**Subject** ▶ Change of Noise Suppressors, Line Coil, Wirings

**For Models** ▶ 1001, 1804N, 2012, 2416S, 2708, 3612B, 3800NA, 401, 5000SB, 5000SBR, 5008NB, 5500S, 6904, 6920N, 6928, BO6010, DA3000, JG1600, JN1600, JS1600, M242, M361, M431, M513, M801, M902, M903, M921, M923, M952

**2) Change of Line Coil: for 1804N only**

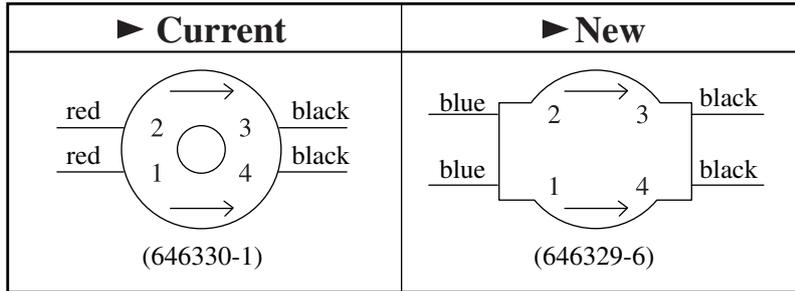
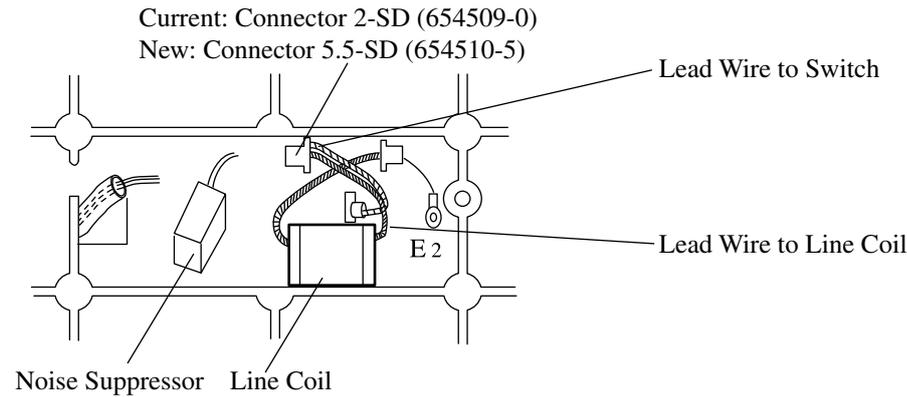
The wiring remains unchanged.

Install the Line Coil in the correct direction as illustrated below so that Lead Wires can't protrude from the space.

2708  
for South Africa,  
Australia

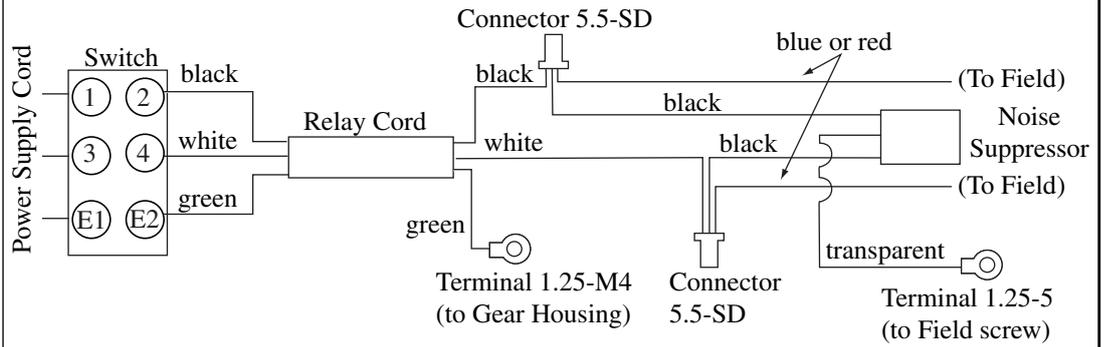
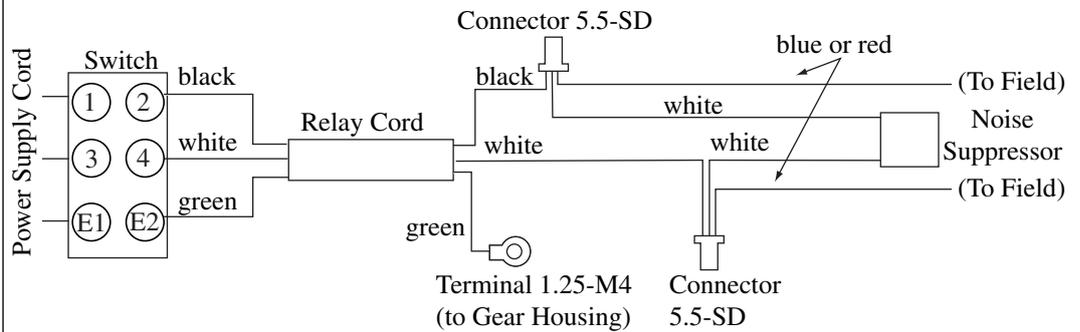
**3) Change of Wiring**

► Current

► New

2708  
for Germany

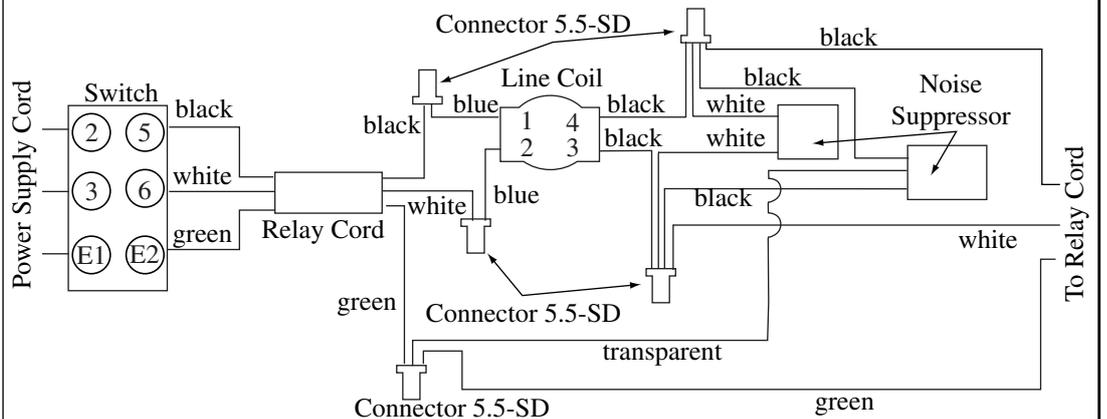
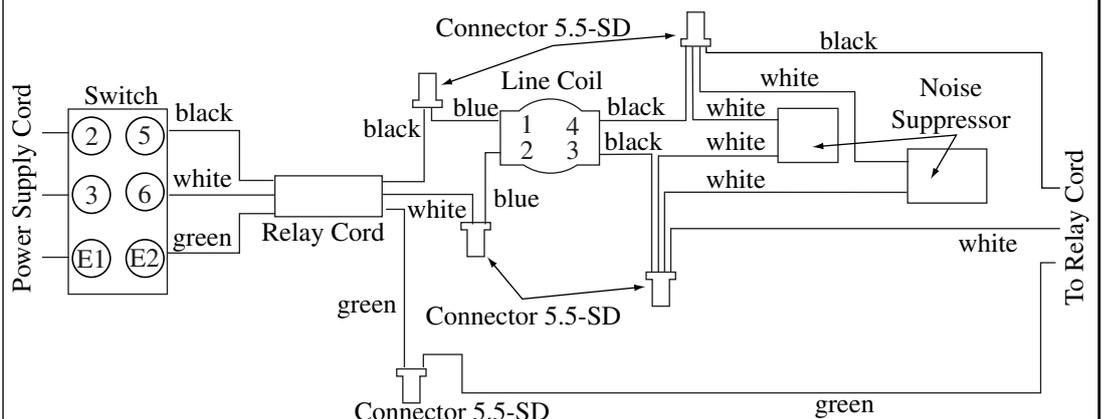
► Current

► New
